CLARK BUILDERS SUBMITTAL REVIEW

PROJECT NAME: **SEVEN GENER.ENERGY COMM. BLDG**  
 LOCATION: **GRANDE PRAIRIE, AB**  
 TITLE: **GENERAL NOTES & SECTIONS**  
 CUSTOMER: **RAMPART STEEL LTD.**  
 ENGINEER: **BEIRSTO & ASSOCIATES**

**PARTIAL SECOND FLOOR DECK FRAMING PLAN (DIV. 01D)**

**Project: SEVEN GENER.ENERGY COMM. BLDG**

**PARTIAL SECOND FLOOR JOIST FRAMING PLAN (DIV. 01A)**

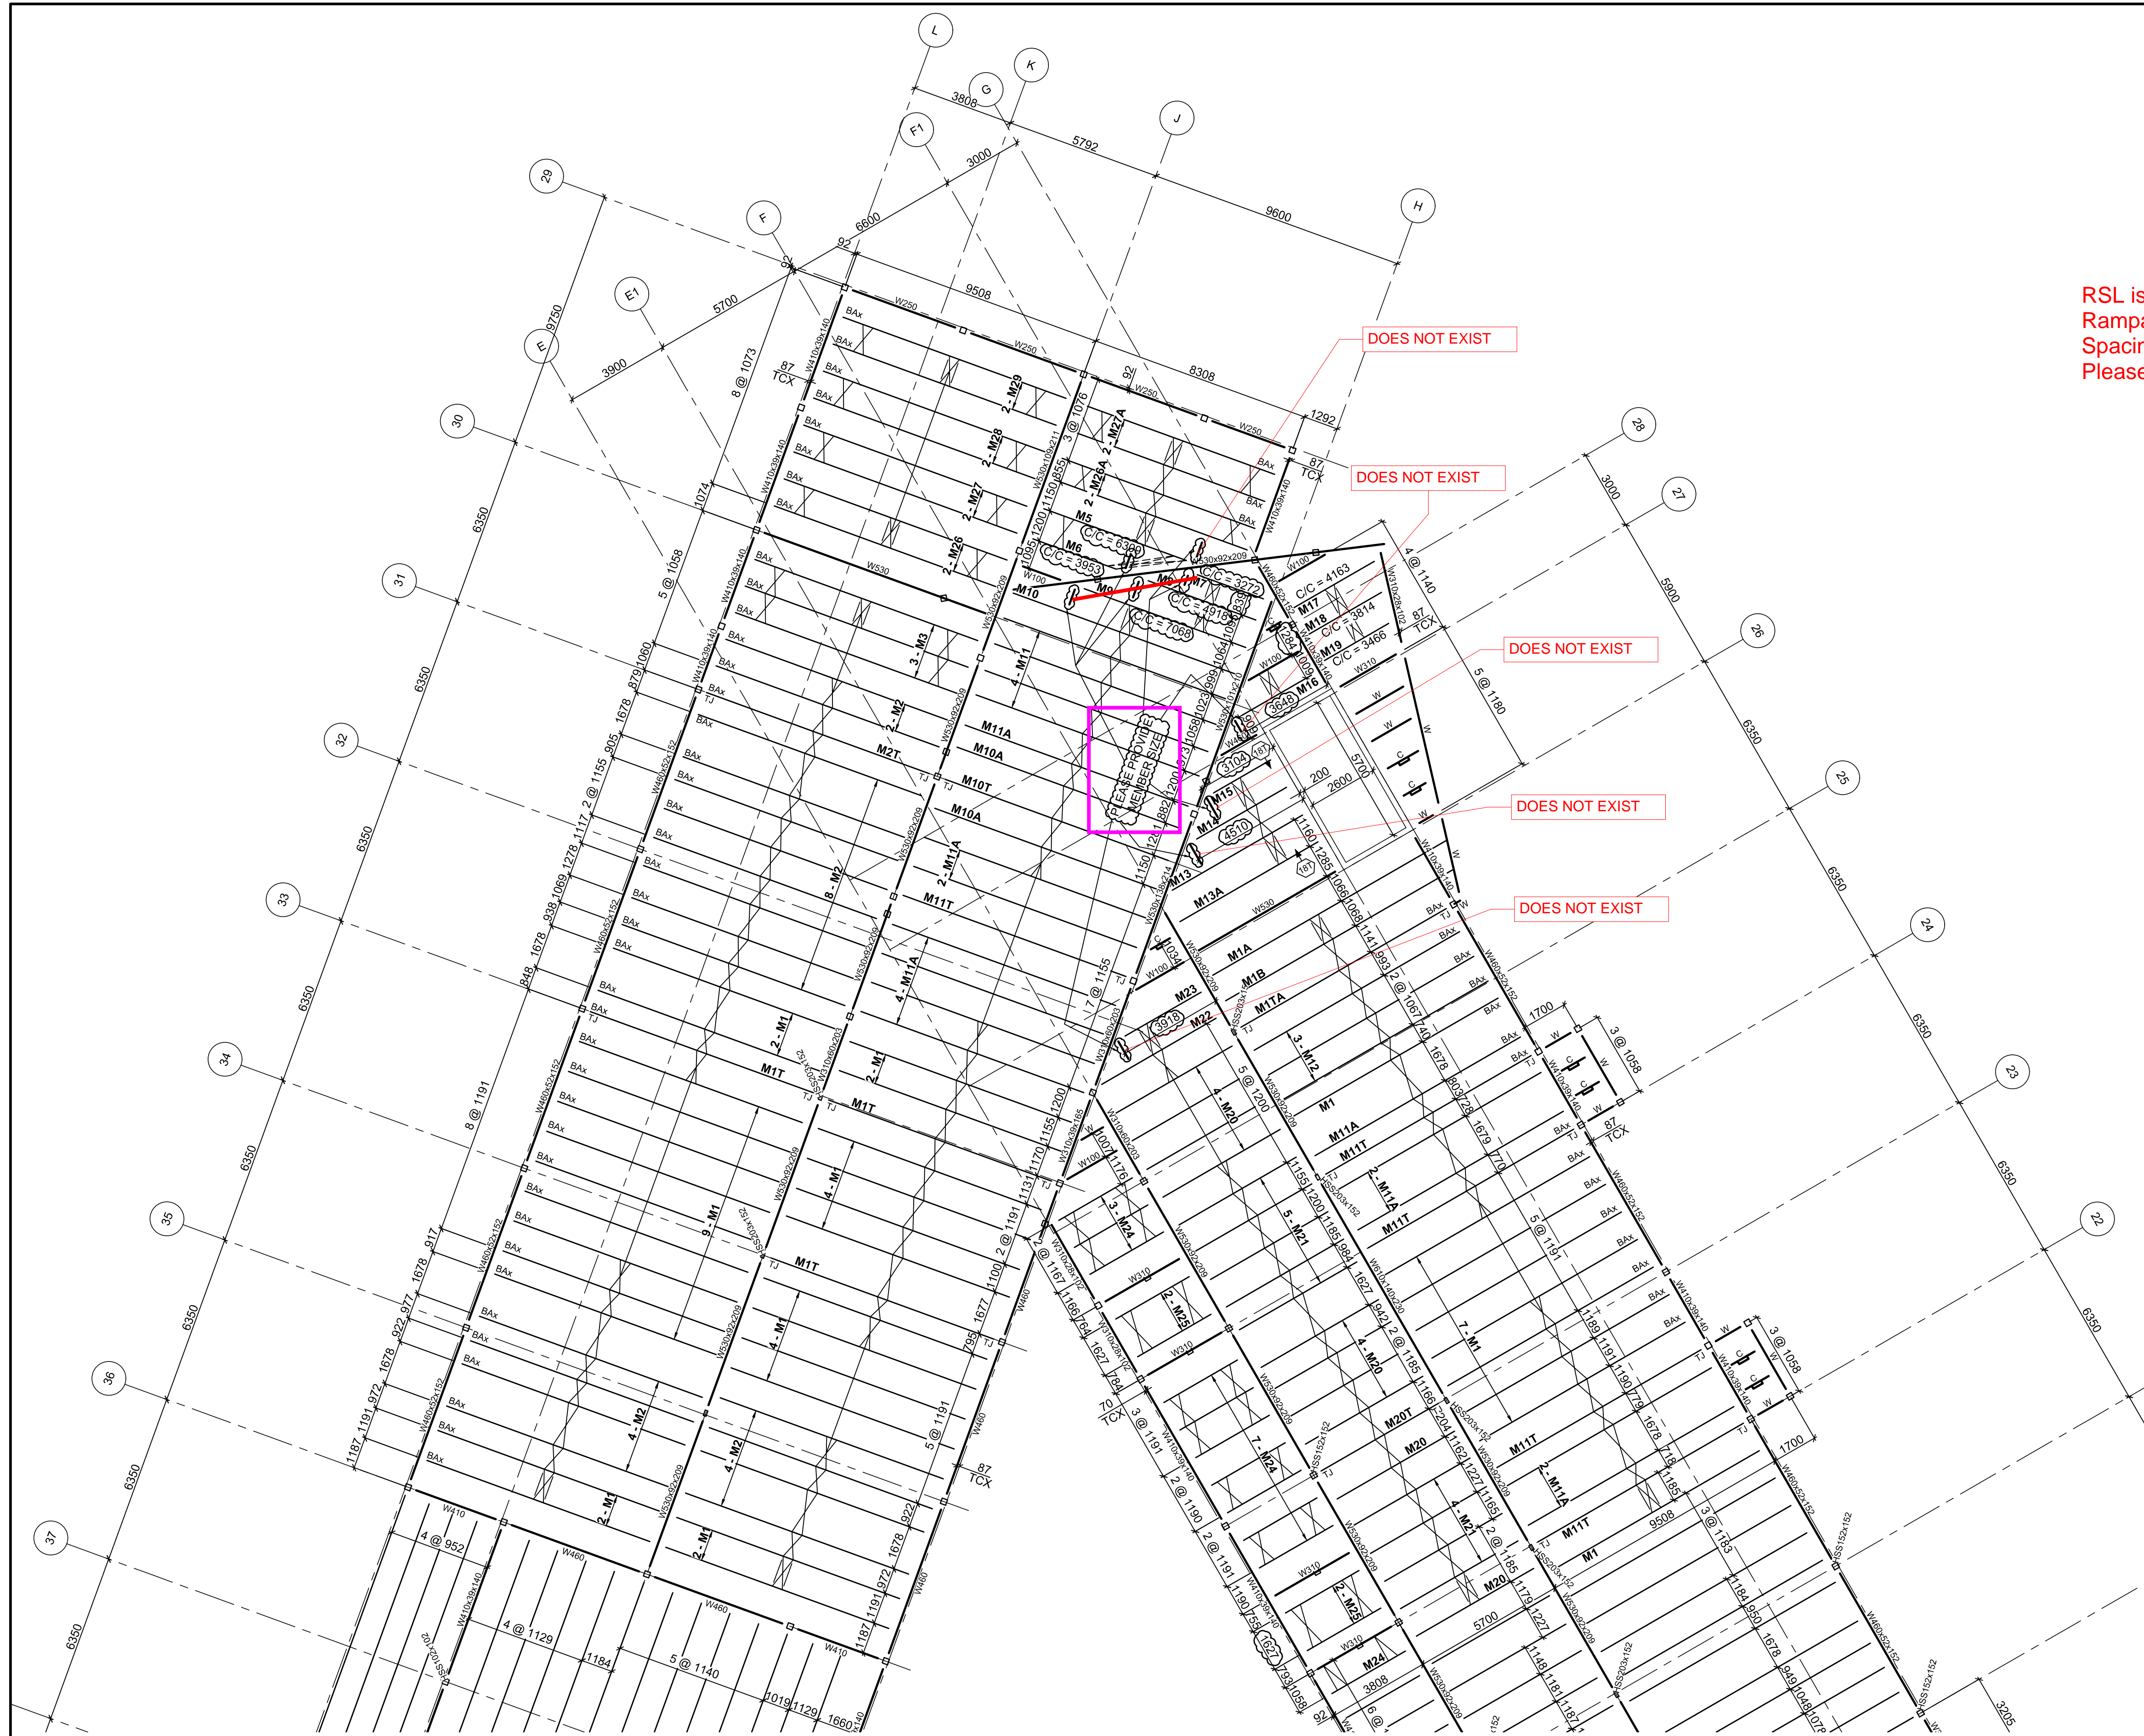
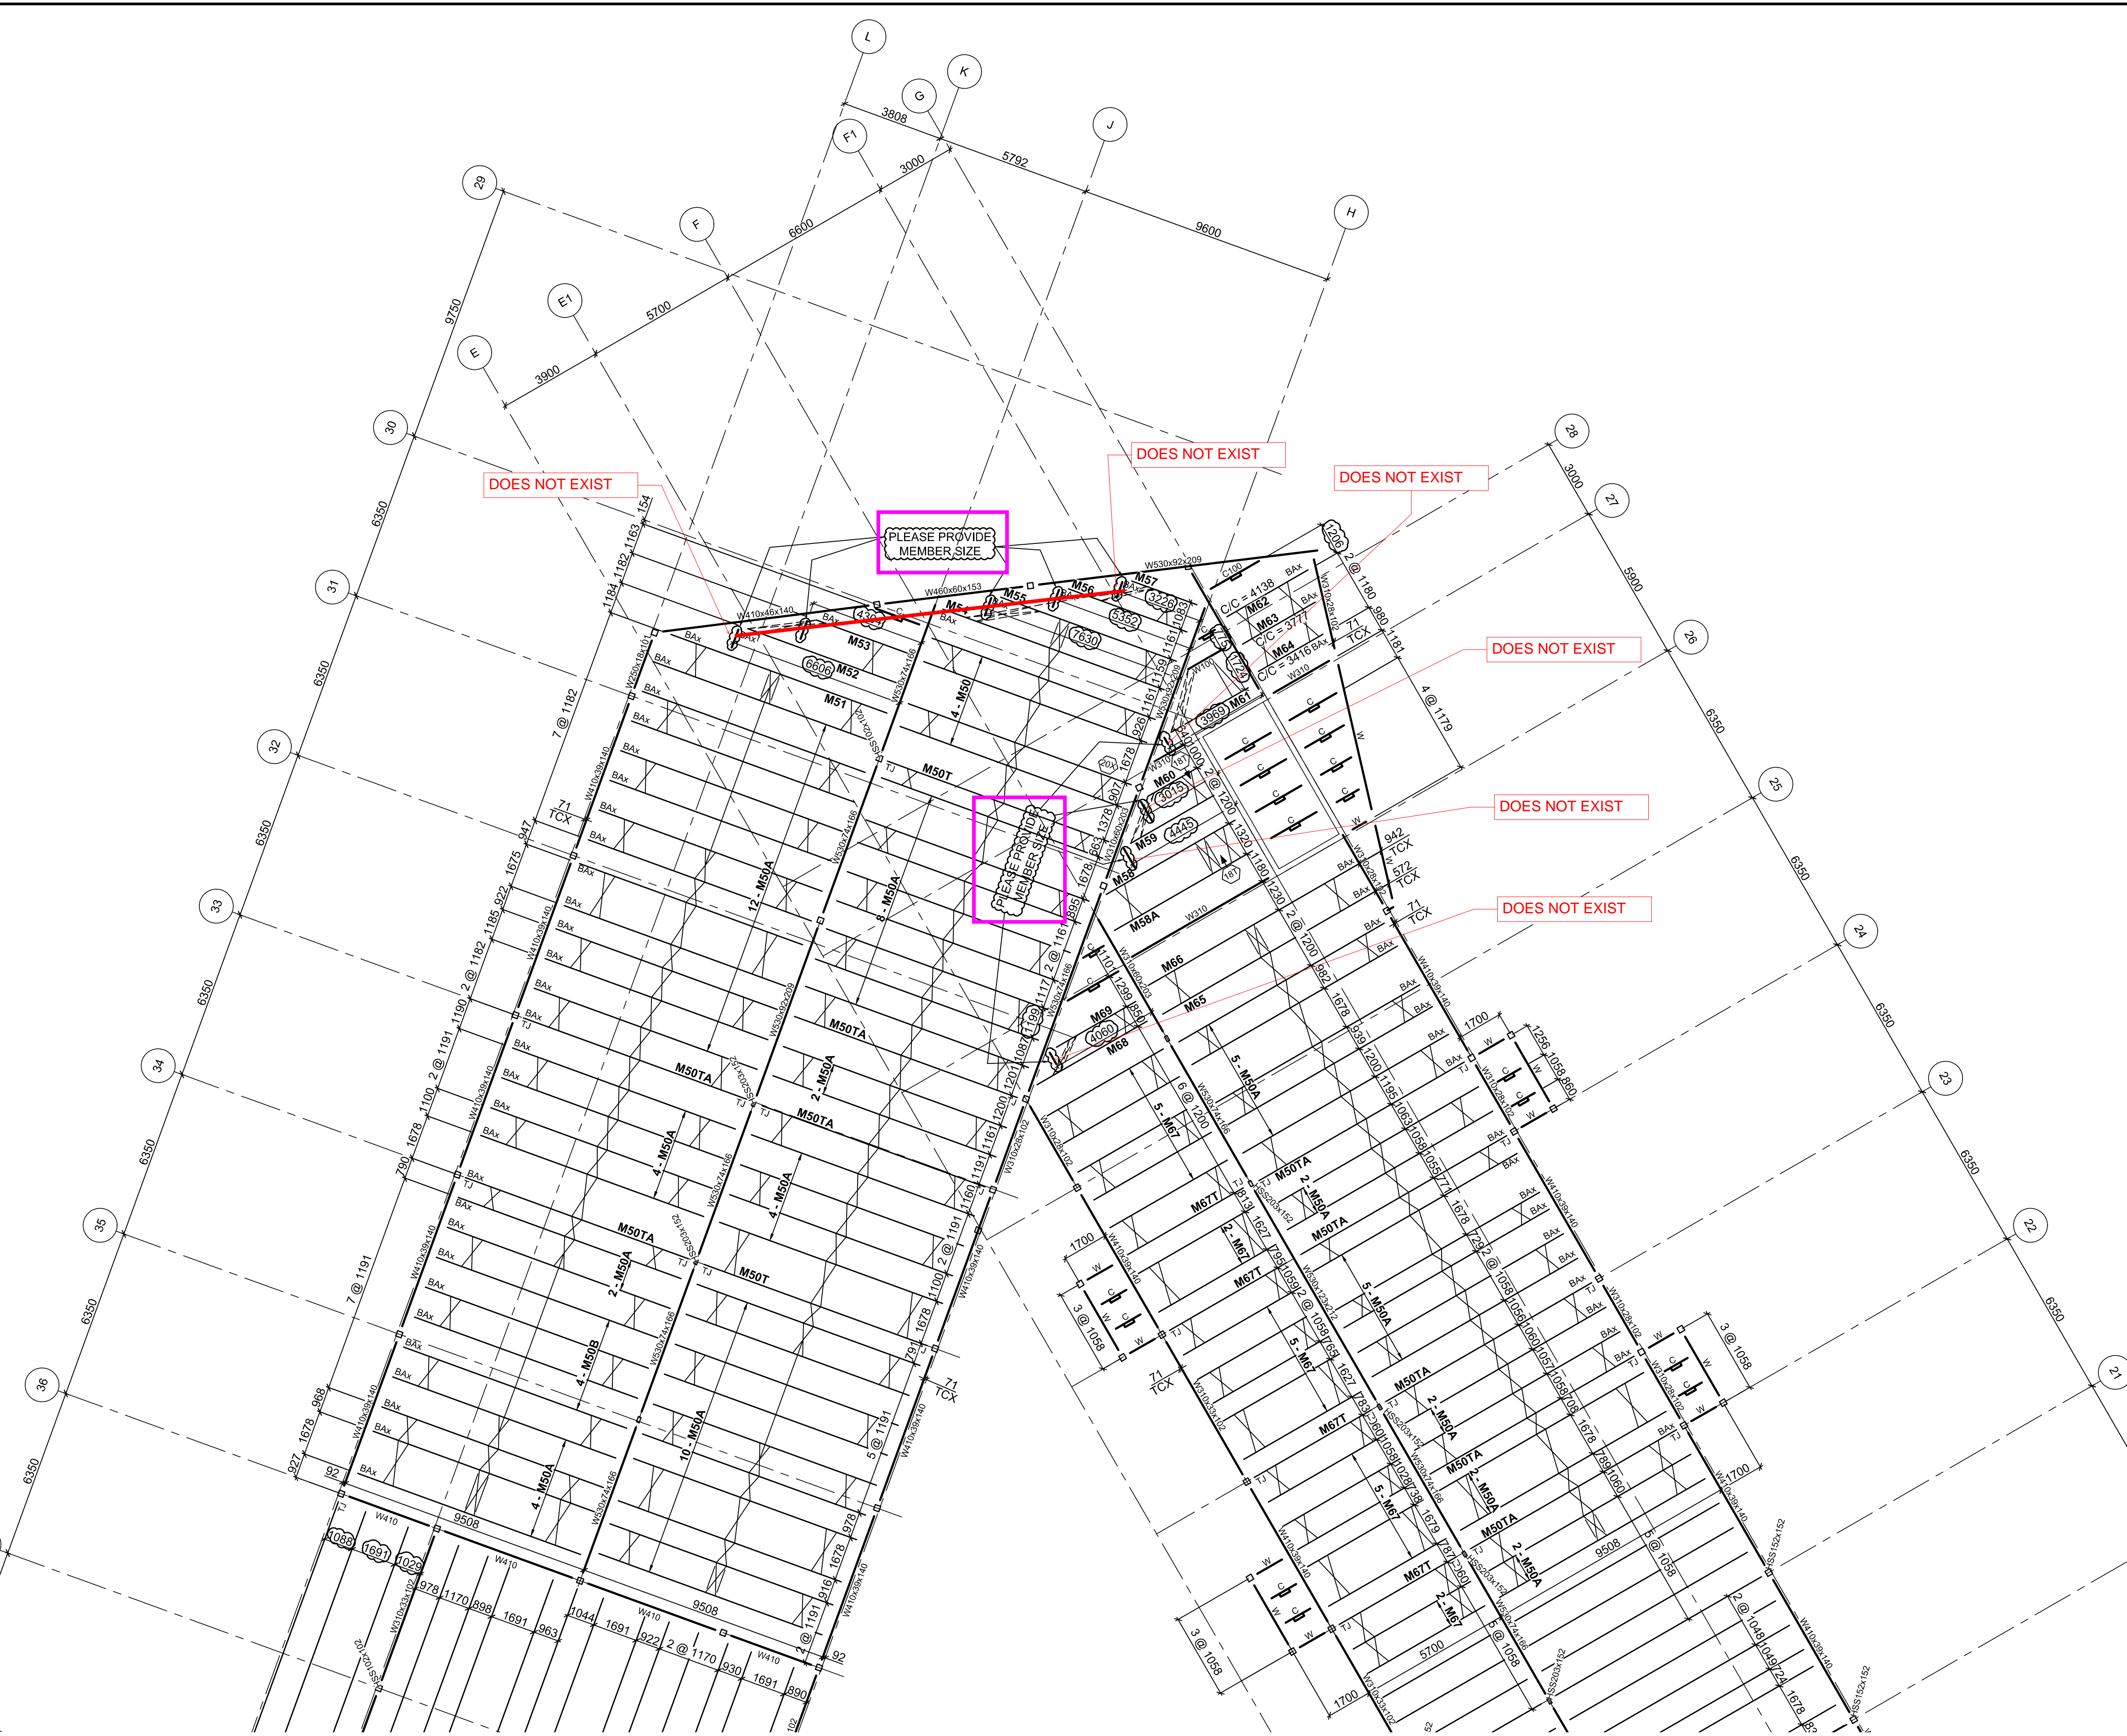
RSL is Aware that Joist Spacing Do not at this time Match with Rampart latest information for Joist. Canam will adjust Joist Spacings to suit Rampart and Project required Spacings. Please review for Design Conformance.

Mark : M2 (Hybrid Mid Span, Symmetrical,, Free ends) aligned on M1

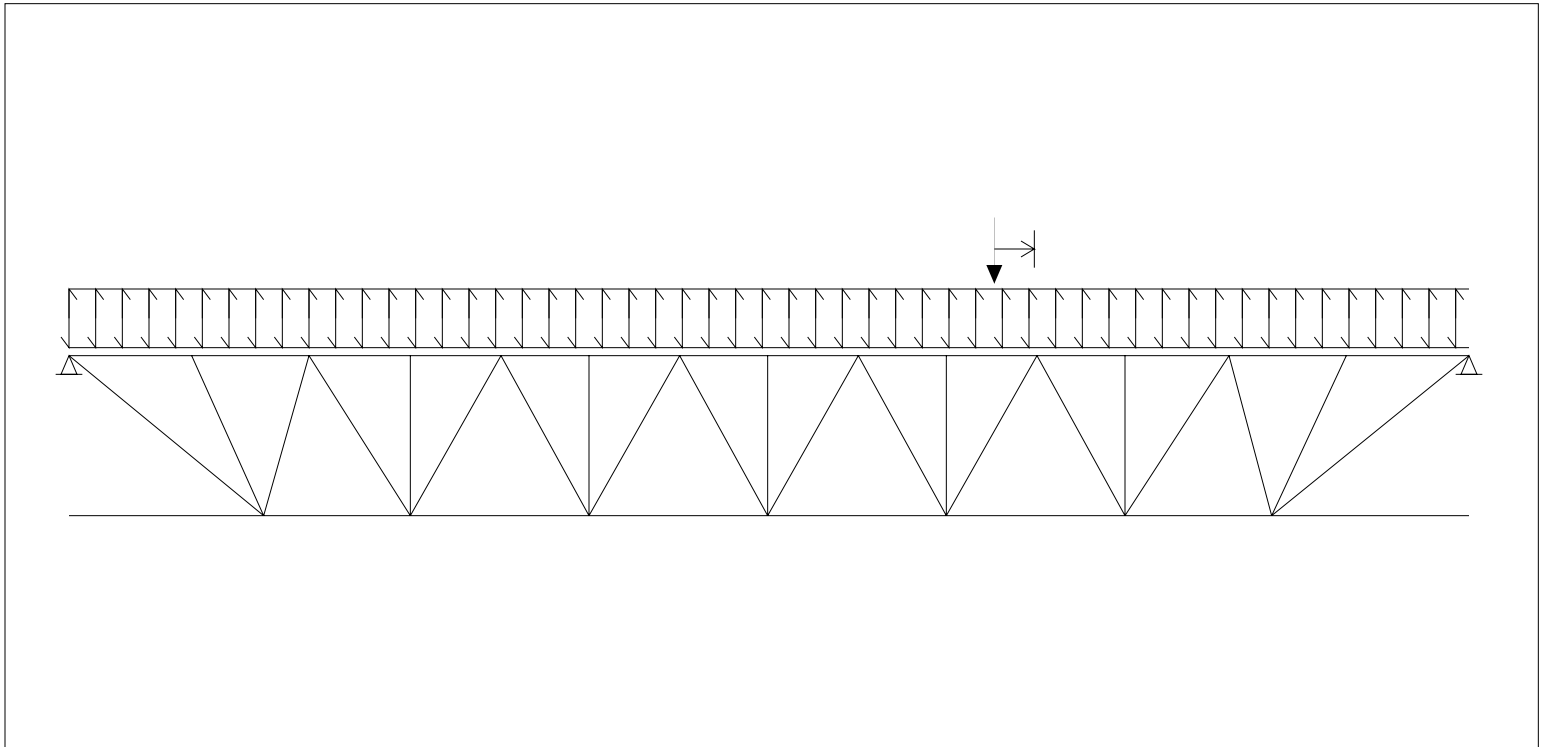
**WHY ONLY  
PARTIAL  
LOAD?**

**EG: M2 SOUTH  
OF GL35 B/W  
GLH AND GLJ  
SHOULD BE  
FULL 4.8 KPA**
